TR 04

REQUEST FOR TECHNICAL REVISION (TR) COVER SHEET

File No.: M- 2000-066 Site Name: RAYMOND ENDERSEN PIT

**RAYMOND ENDERSEN PIT
(M-2000-066)**

MINING MAP

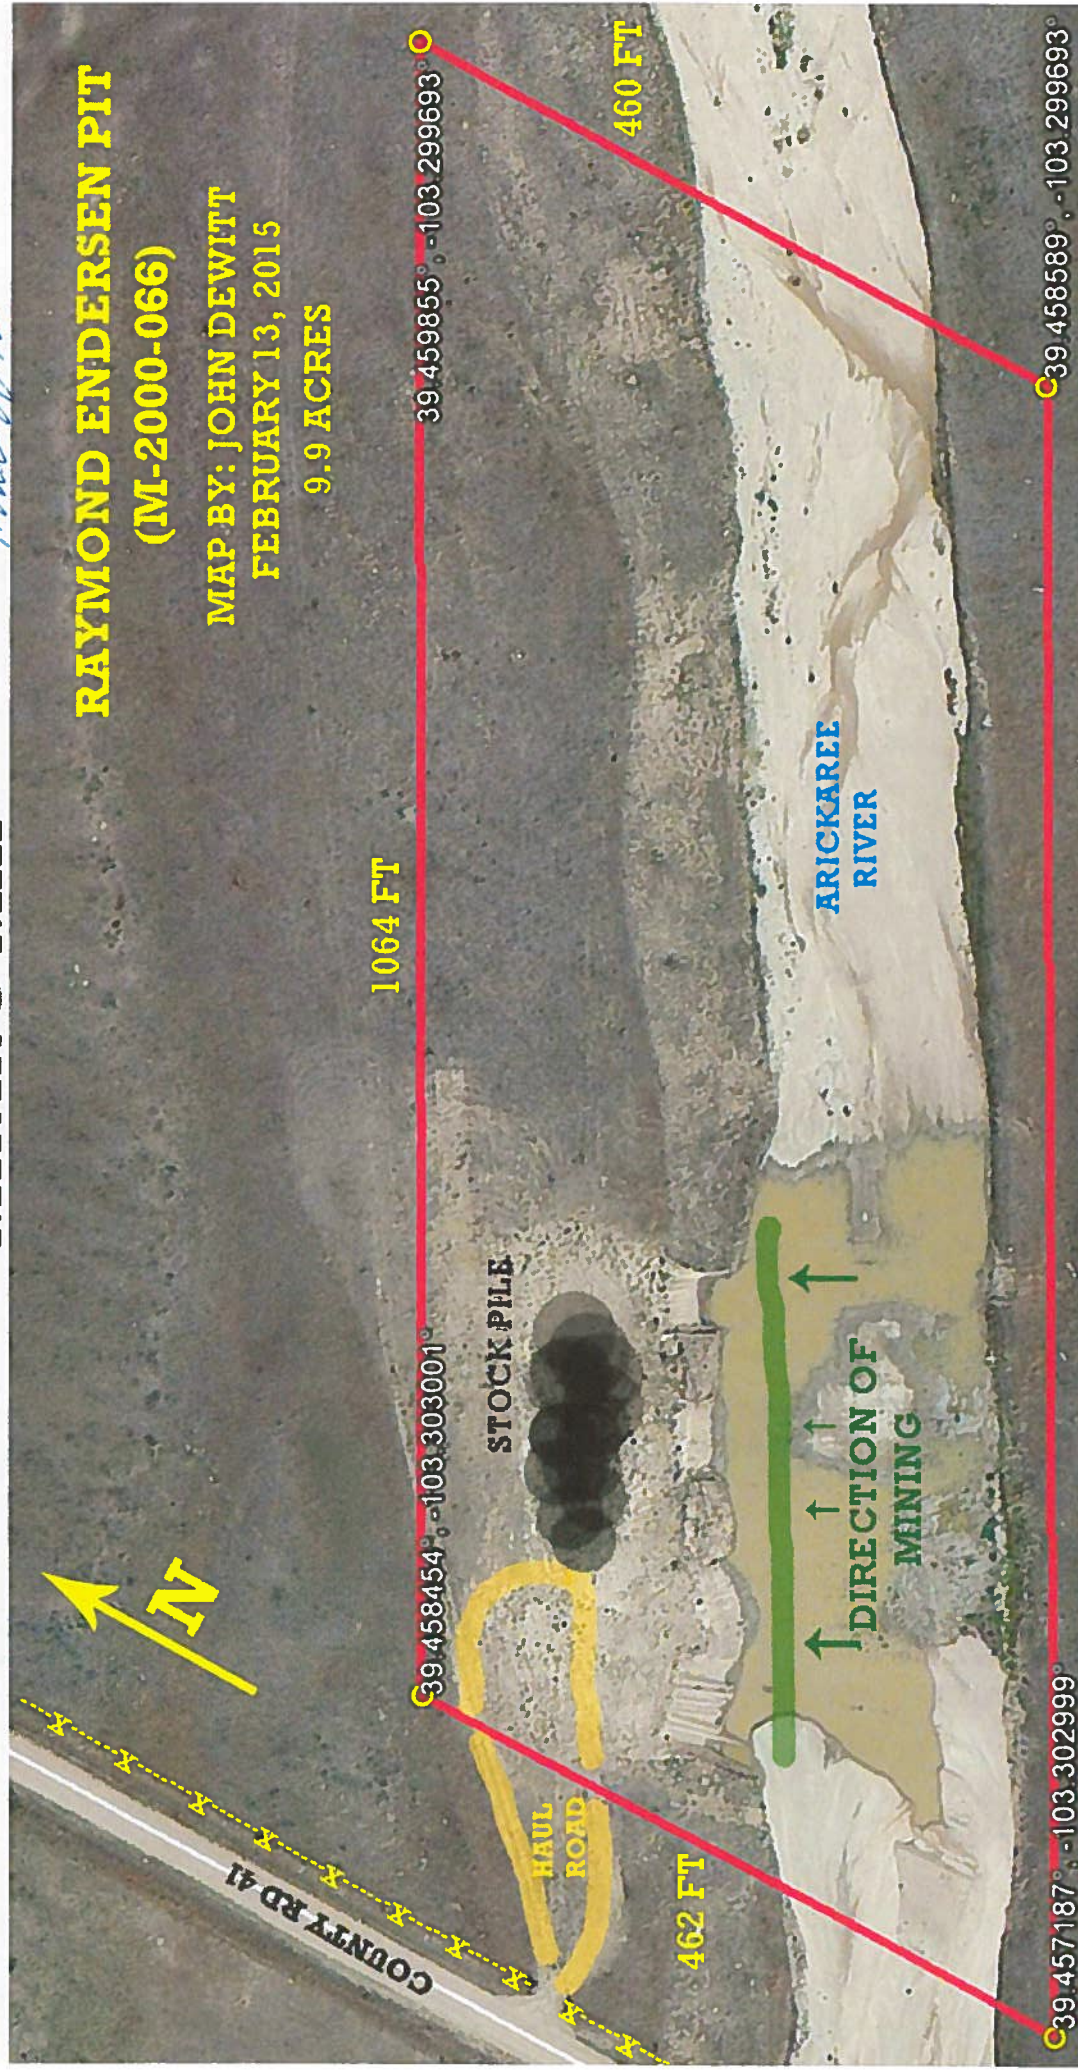
Please provide a brief description of the proposed revision: BOUNDARIES OF THIS PIT WERE DETERMINED TO BE INACCURATELY DEPICTED ON THE ORIGINAL MAP. THIS

REVISION IS INTENDED TO CORRECT THE INACCURACIES. (SEE MAP)
